AGENDA MEMORANDUM

Title: **The Ridge at Crystal Valley Site Development Plan; and
The Ridge at Crystal Valley Skyline Variance**

Viewing Platform and Skyline Area Map

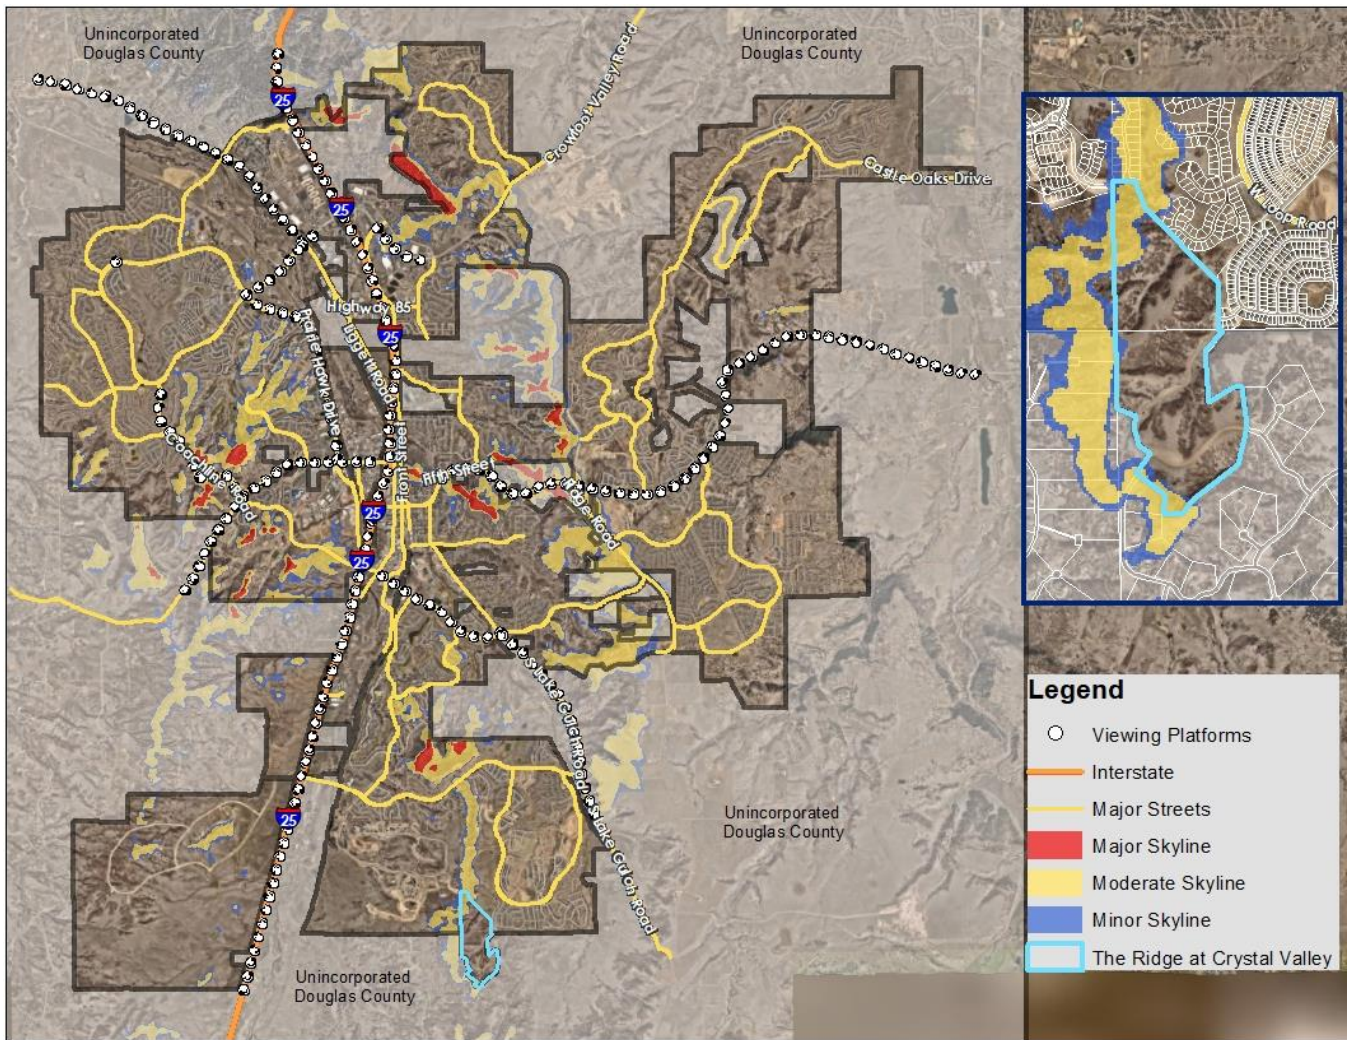
The SDP proposal for the Ridge at Crystal Valley has 25 lots which lie wholly or partially within a designated Moderate Skyline Area. For these 25 lots the applicant is requesting a Skyline Variance in order to increase the maximum permitted height to 35-feet from 25-feet.

To support the variance request, a Skyline study was performed and submitted by the applicant. The study analyzed all 25 lots and whether or not a 25-foot high structure, if built upon the lots, would be visible in the skyline from each of the 232 viewing Platforms. The study used proposed finished grades for all 25 lots. The study found that homes 25-feet in height built upon the lots would not be visible in the skyline from a large majority of viewing platforms. This is because the proposed finish grades of the lots are well under the current natural grades of the lots, due to the required grading for the road connection to Lanterns.

For the 25 lots, a 25-foot high structure on lot 2 will have the most visibility in the skyline, being visible in the skyline from 16 viewing platforms but not visible from 216 viewing platforms. Lot 13 will have the least visibility in the skyline, being visible in the skyline from 5 viewing platforms but not visible from 227 viewing platforms.

Therefore, the applicant is requesting that the restriction of the Minor Skyline Area, which has a 35-foot maximum height restriction apply to all 25 lots, rather than the restrictions of the Moderate Skyline Area, which has a 25-foot maximum height restriction. In addition, the applicant will meet all visual impact mitigation requirements. Staff has reviewed the complete study and concurs with the conclusion.
